Fig.1. Method of Modifying the Fuse Holder

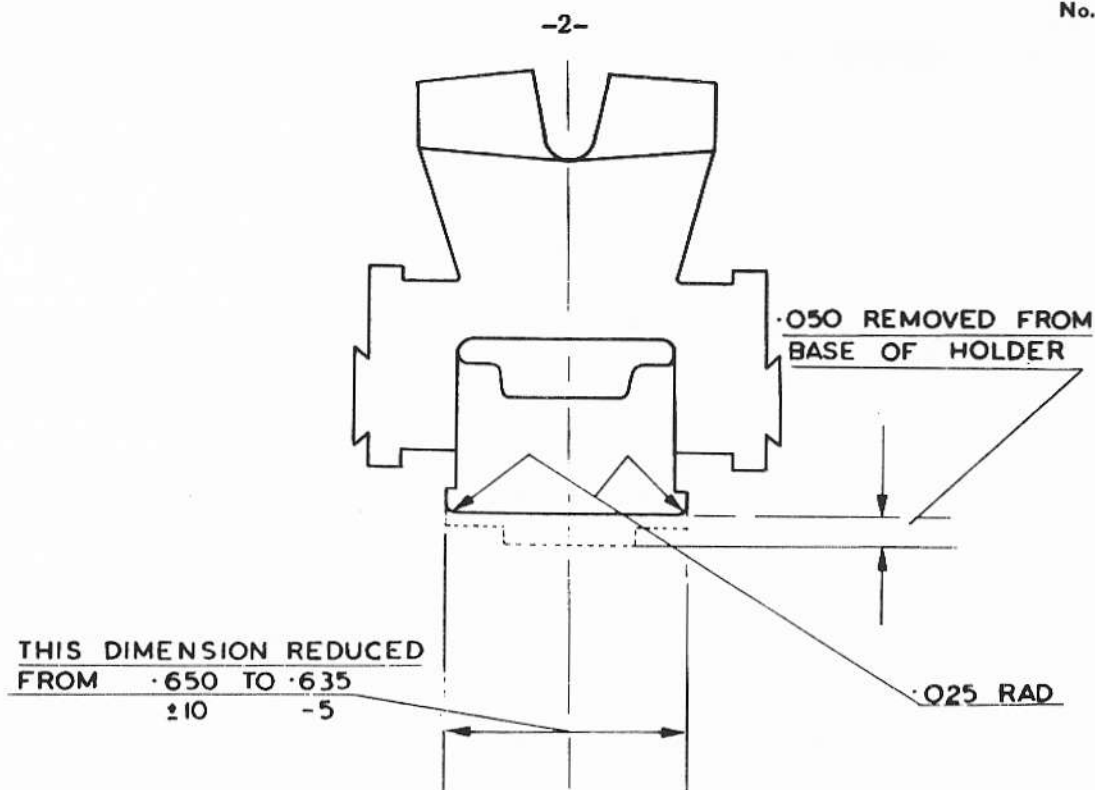
On late S1 cars and certain S2 cars, failure of the fuses to make good contact may be due to the fuse wires being located too high in the fuse clips. This fault can be attributed to one of the following causes.

- (a) Dimensional differences which produce a foul between the base of the fuse holder and the fuse clips, thereby preventing the holder from being pushed fully down into the clips.
- (b) The copper contact strips being incorrectly fitted, do not locate correctly on the moulding, which means that unless the fuse is carefully assembled the wire makes poor contact.

Remove .050 in. from the bottom of the fuse holder and reduce the width of the bottom to between .630 and .635 as shown in Figure 1.

This allows the position of the fuse wire to be lowered from .425 in. to .375 in. and enables the fuse holder to fit fully down between the clips.

Fig.2. 'A' Correct Method of Fitting the Fuse Wire,
'B' and 'C' Incorrect Method

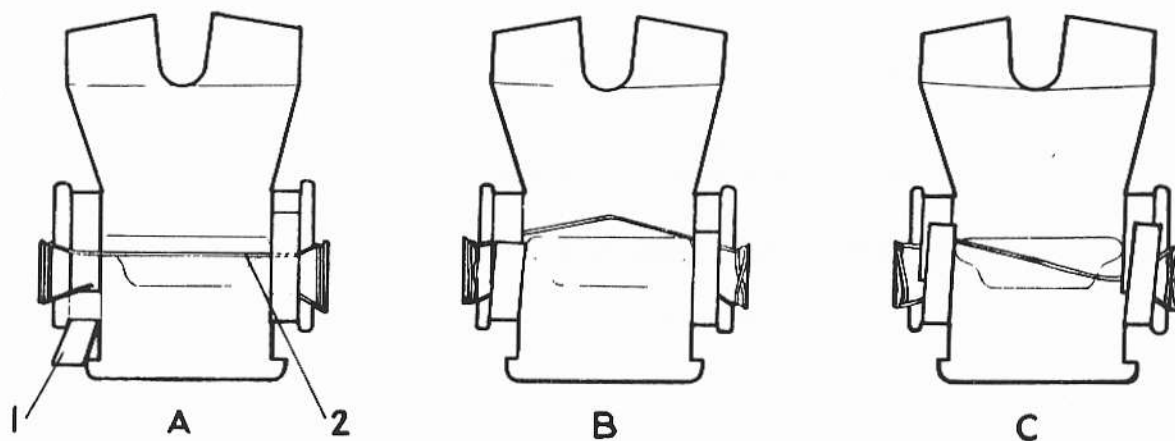
Ensure that the wire is wrapped around the bollard on the fuse holder one and a half times, and passed across the air space along the ledge, parallel with the bottom of the holder, then wrapped around the other bollard one and a half times. The ends of the wire must be positioned so that they are securely trapped by the copper strips when they are fitted.

The correct method of fitting the wire is shown, in comparison with incorrect methods, in Figure 2.

Fit the copper strips to the fuse holder so that the fuse wire is firmly trapped and that each end of the copper strip overlaps the wire by an equal amount. The correct method of fitting the fuse wire and the contact strips is shown in 'A' of Figure 2.

Fig.3. 'A' Fuse Clips set Incorrectly.
'B' Correctly.

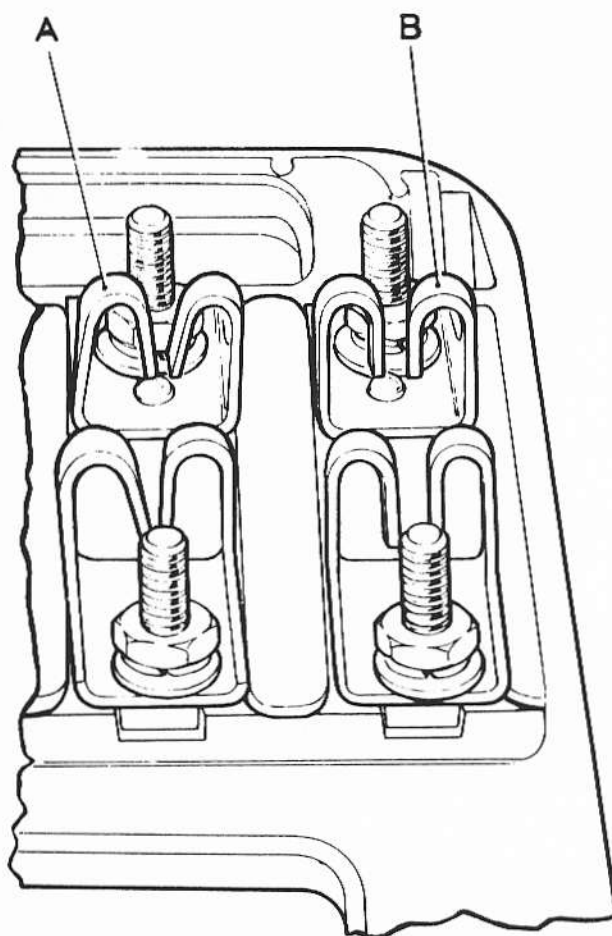
Ensure that the fuse clips are not distorted. They should be set square and parallel in order to maintain the holder firmly in position.

Figure 3 shows a comparison between the fuse clips set correctly and incorrectly.

Fig.1. Positioning of Starter Motor Relay and Re-wiring of Connections

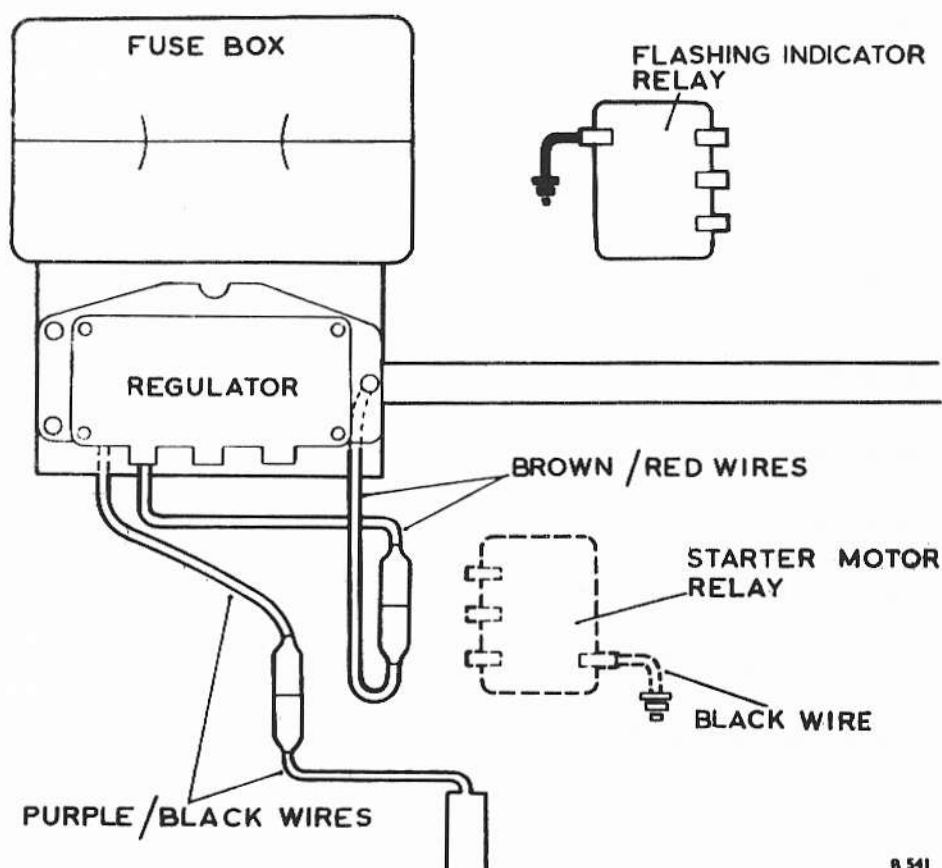
A protective device, in the form of a relay switch, was fitted to S2 cars to prevent drivers from engaging the starter motor pinion when the engine was running. Recent Service experience has shown that this relay does not function correctly and Retailers and Service Personnel should remove these relays when affected cars next come in for Service or in the case of customer's complaint.

Remove the two Brown/Red wires from the connection W.1 on the relay and connect them together using a double-ended 'Lucar Blade'

connector (UD.6074), (See Fig.1).

Remove the two Purple/Black wires from the connections C.2 and C.3 on the relay and connect them together using another double-ended connector (UD.6074).

Remove the Black earthing wire from the connection W.2 on the relay and from the bulkhead.

Remove the relay. The two cheese-headed screws and washers should be refitted to the bulkhead.

Figure 1. Direction indicator switch (UR 16530)

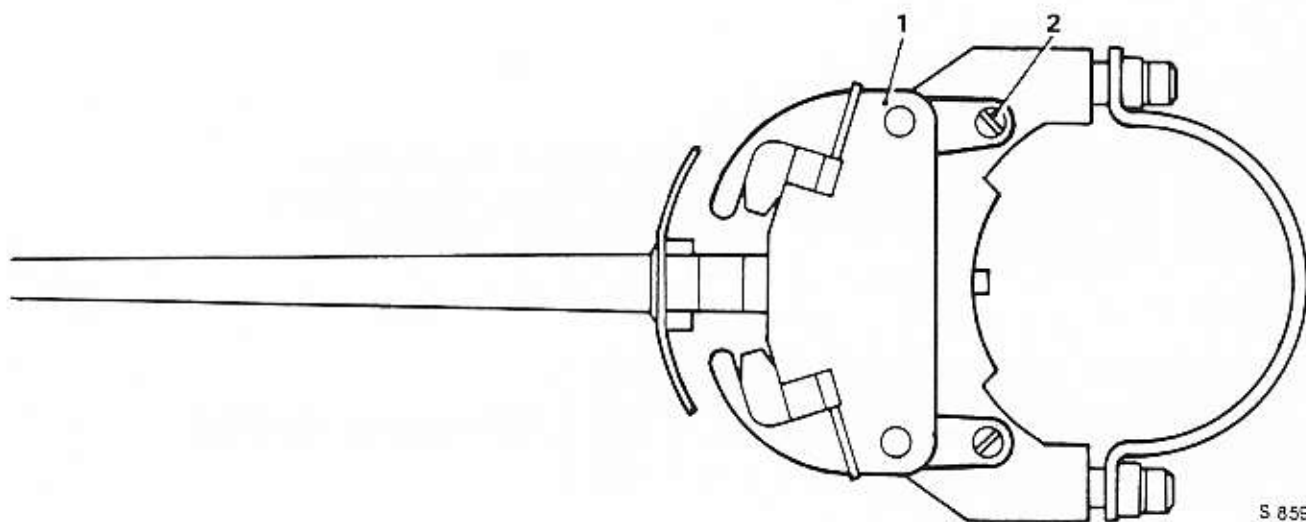
The direction indicator switch UR 5273 is no longer available. For replacement purposes, the switch used on Silver Shadow cars (UR 16530) will be fitted. When it is fitted, the terminal connectors must be changed.

1. The removal and replacement procedure for the new switch remains the same as for the old. However, there is a small modification to be carried out on the new switch as follows:
2. Remove the two screws and discard the brown insulation board (see Fig. 1). Replace the screws with a washer (X 4401) behind each screw head (see Fig 2).
3. Cut the 7 pin plug off and withdraw the insulation board along with the green/yellow and green/blue wires.
4. Fit 'Lucar' connectors to all the wires except the black one to which a bullet connector is fixed. Connect the wires as follows.
